**Official Transcript of Proceedings**  
**NUCLEAR REGULATORY COMMISSION**

Title:                   Advisory Committee on Reactor Safeguards  
                              Regulatory Policies and Practices  
                              Subcommittee

Date:                 June 6, 2017

REGULATORY POLICIES AND PRACTICES SUBCOMMITTEE

# Pressurizer and SG SV FTC Open Area Fraction

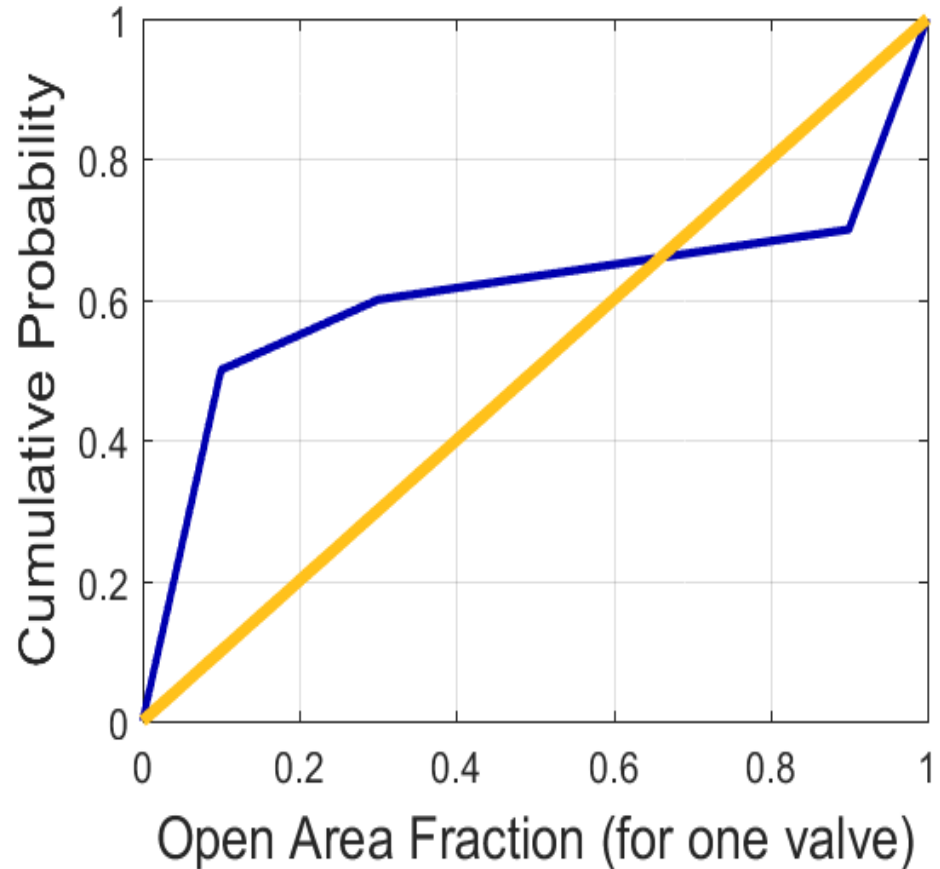
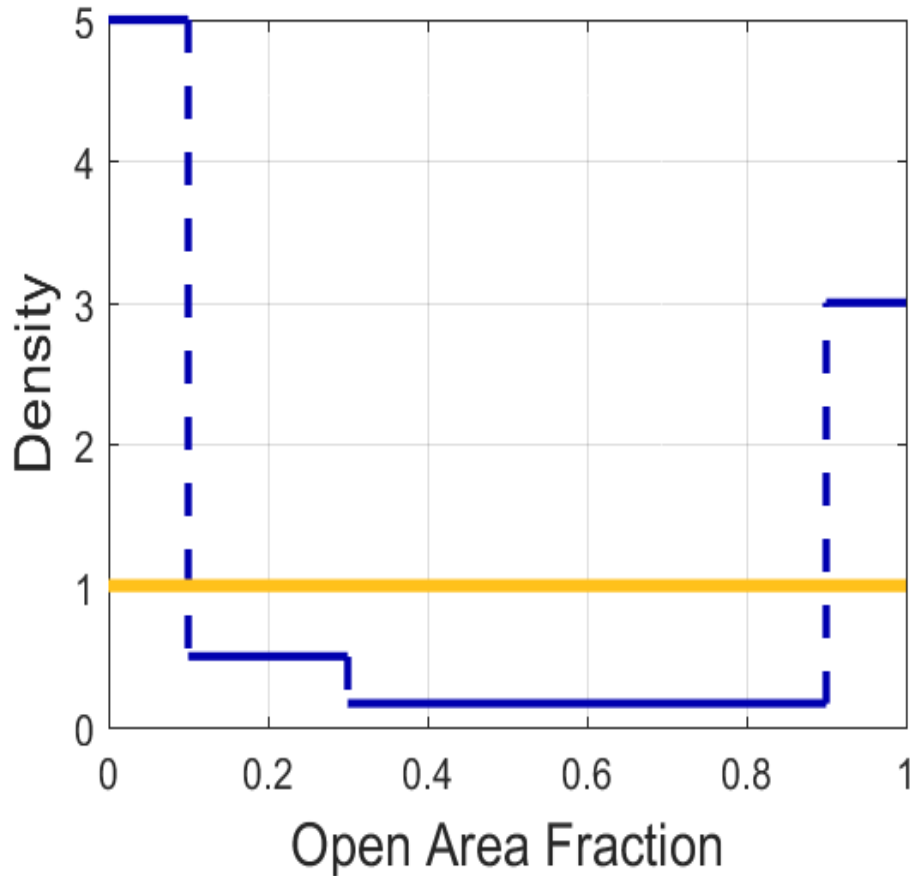
14 Let me quickly talk about the open area for  
15 action. We already talked a little bit about this. So  
16 the orange curves on these two graphs show what we had  
17 done last year in the draft UA. We essentially assumed  
18 a uniform distribution between just if it fails to close  
19 being one-percent open all the way to fully open. So  
20 we thought we don't have much information, and we just  
21 assigned an equal probability to the whole range.

18 CHAIRMAN STETKAR: Yes. So now we  
19 questioned last year your use of a uniform distribution  
20 anywhere from 0 to 100 percent, so you have changed that  
21 such that now, it is a uniform distribution between 50  
22 and 100 percent.

1                   CHAIRMAN STETKAR:  If there's a very, very  
2 high likelihood that the things behave as designed, why  
3 isn't there a very, very high conditional probability  
4 that the open fraction is 1, with a small probability  
5 that it is less than 1?  In other words, something that  
6 looks more like the shape of the distribution that we  
7 were talking about for the failure to close area  
8 fractions rather than -- than what is now what you show  
9 here?

18 CHAIRMAN STETKAR: And that is why now, in  
19 terms of our trying to capture uncertainty in this study  
20 is why I am questioning this new distribution. Is it  
21 consistent with what we understand about the design  
22 operation of those doors and the information from that  
23 previous study? It doesn't seem to be.

22 MR. ESMAILI: Correct. And so -- so, and  
23 as you can see, to tell you honestly, you know, you're  
24 right. Maybe if we go back, we are going to put more  
25 weight on more of it is open. As a matter of fact, the

# Ice chest inlet plenum doors (ajar)

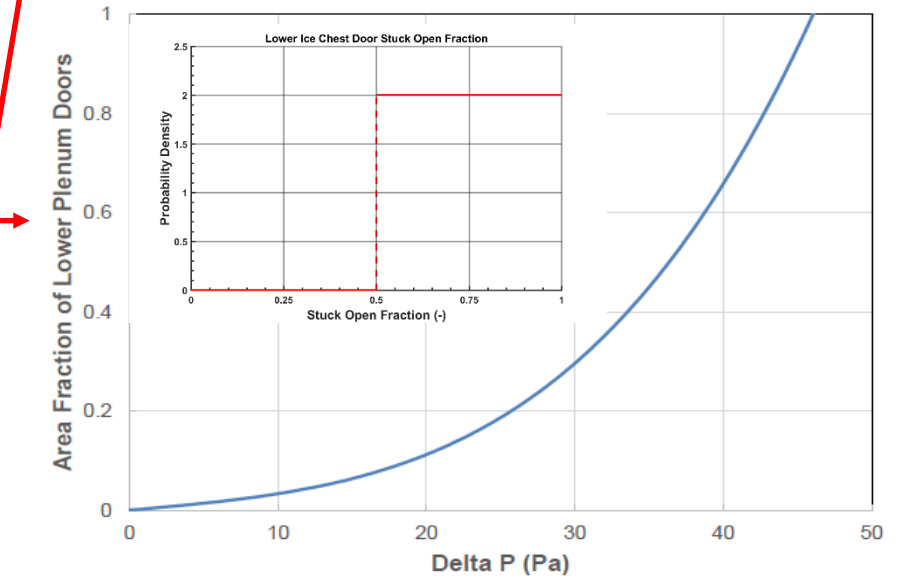
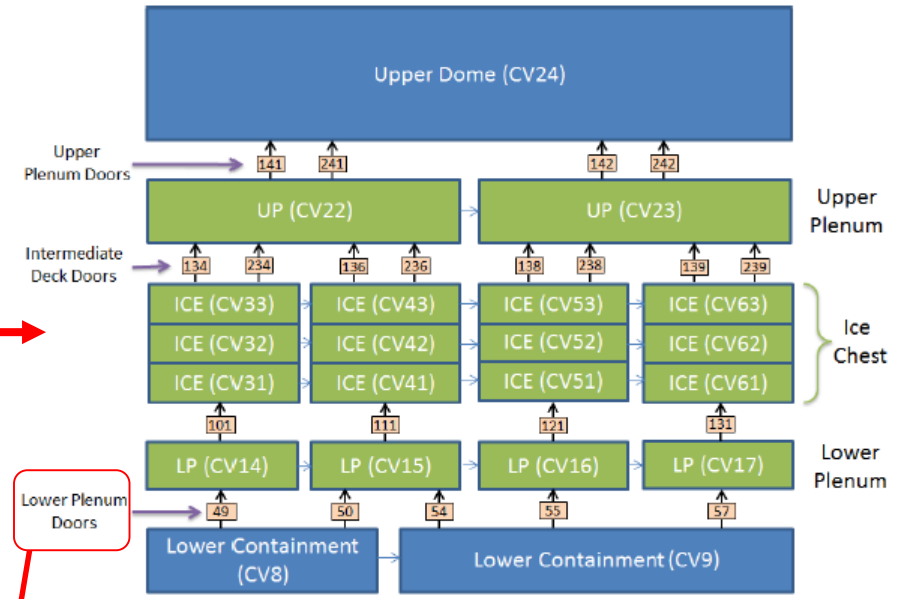
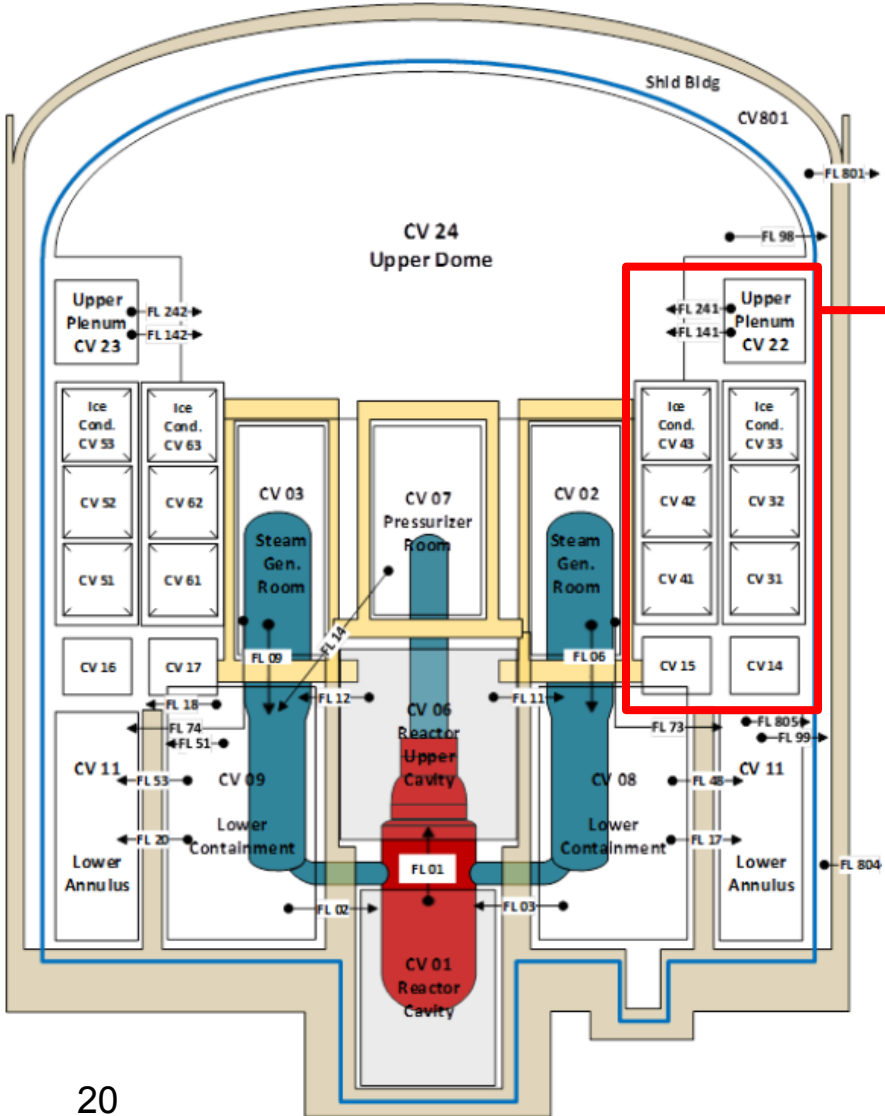
18 CHAIRMAN STETKAR: -- and I do want to come  
19 back to the next slide. I've got some questions on it.  
20 But let's talk about the doors first so we --

17 MR. ESMAILI: Okay. So the low -- so the  
18 lower plenum doors, there are 24 double doors, total  
19 of 48. Okay. There are 24 double doors, correct? Or  
20 -- yes, 24 double doors. Okay, I got -- and so these  
21 doors are normally closed during operations. They  
22 have a negative pressure on the ice itself, so they  
23 remain closed, but during the accidents, they can open,  
24 and they open very, very easily.

9 MR. ESMAILI: -- doors. But the  
10 important thing was that we had to break up the ice chest  
11 itself into actually at least three number of actual  
12 nodes to be able to capture, you know, the -- the  
13 conditions inside the -- the ice. So does that answer  
14 your question?
